**COMMENTS ON THE
GRPE DRAFT ECE COMPRESSED GASEOUS HYDROGEN (CGH₂) REGULATION
Version 10 Dated 06.11.02
(NON GRPE/ISO HARMONIZATION)**

GRPE - 001

2002-12-18

Figure X: Flex-impulse testing fixture

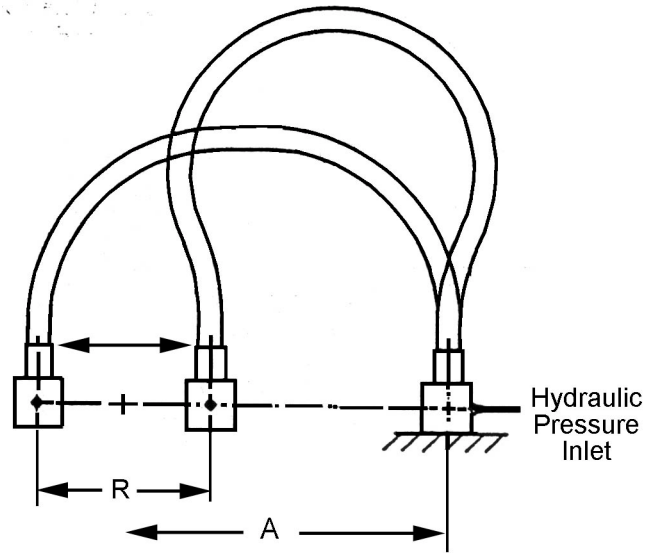
Annex 8, B5.2.3	EIHP2/Powertech	Replace the existing text with the proposal at the end of this document

Replace B5.2.3 with a combined flex-impulse test adapted from SAE J1405.

B5.2.3 Flexible Fuel Lines

The length of the flexible part of the *Flexible Fuel Line* with its fittings attached, to be used in the following test shall be calculated as follows:

$$L = 4.142R + 3.57D$$

The *Flexible Fuel Line* shall be bent in the manner depicted in Figure X and attached to a fixture in that position by the *Fittings* with which it is to be approved. One end of the *Flexible Fuel Line* shall be attached to a reciprocating manifold and the other end shall be attached to a stationary manifold connected to a hydraulic supply. The *Flexible Fuel Line* shall be pressurised quickly by means of a quick opening solenoid valve, such that one cycle consists of holding the pressure at 1.25 times the *Working Pressure* for 10 ± 1 seconds (except for *Flexible Fuel Lines* with a required material temperature of 120°C where the hold pressure shall be 1.37 times *Working Pressure*) and then reducing it to less than 0.1 times the *Working Pressure* for 5 ± 0.5 seconds. The total number of test cycles shall be equal to 2.0 times the number of *Filling Cycles* or *Duty Cycles* as appropriate to the use of the *Flexible Fuel Line* in accordance with Paragraph 2.4.6 or 2.4.7 of this Regulation as appropriate. 50% of the test cycles shall be performed at the minimum and the remaining 50% at the maximum material temperature in accordance with Paragraph 2.4.5.1 of this Regulation.

Superimposed on the hydraulic pressure cycles is a flexing cycle. The flexing rate shall be $36 \pm 2\%$ of the hydraulic pressure cycling rate. This assures that the *Flexible Fuel Line* is in a different configuration on each succeeding pressure cycle impulse. The test fixture is shown in Figure X with the distance A calculated as:

$$A = 1.75R + D$$

The *Flexible Fuel Line* shall not show any visible signs of damage.
